Urgent Field Safety Notice

Prismaflex Control Unit FA-2019-050 Device Correction

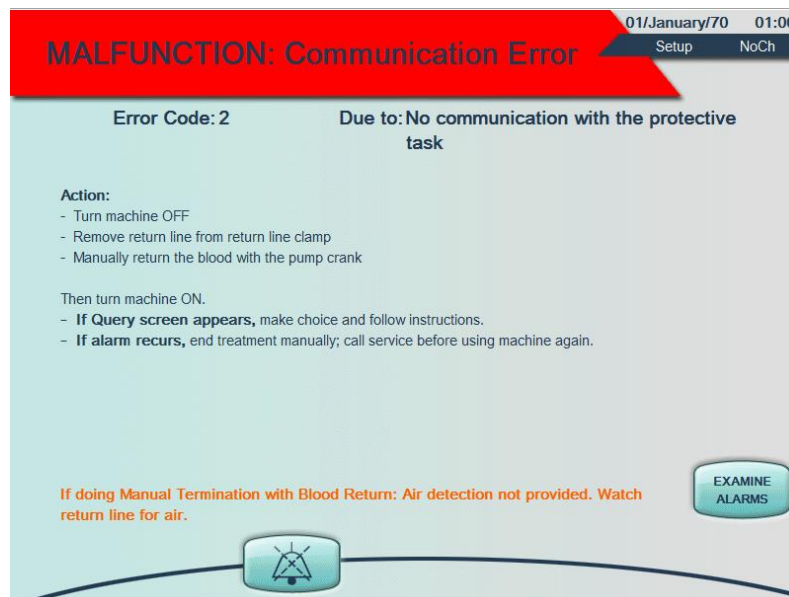
The following actions occur during a communication error alarm:

- The Prismaflex control unit enters a “safe state” by stopping all pumps and closing the return line clamp. Treatment is suspended. The patient’s blood does not circulate through the blood flow path.
- Red flashing light
- Recurring high-pitched sound of 10 sound pulses repeated approximately every 8 seconds until muted.
- Malfunction screen appears on the display as pictured below. The instructions to the user are the same for all error codes.

1. Operators may continue to safely use the Prismaflex control units until the upgrade is performed. If a communication error alarm does occur, follow the instructions presented on the graphical user interface and/or in the operator’s manual. Please reinforce the importance to manually return the extracorporeal blood to the patient, and re-train users on this process, outlined on page 10:57 (to be adapted locally) of the operator’s manual, if necessary.
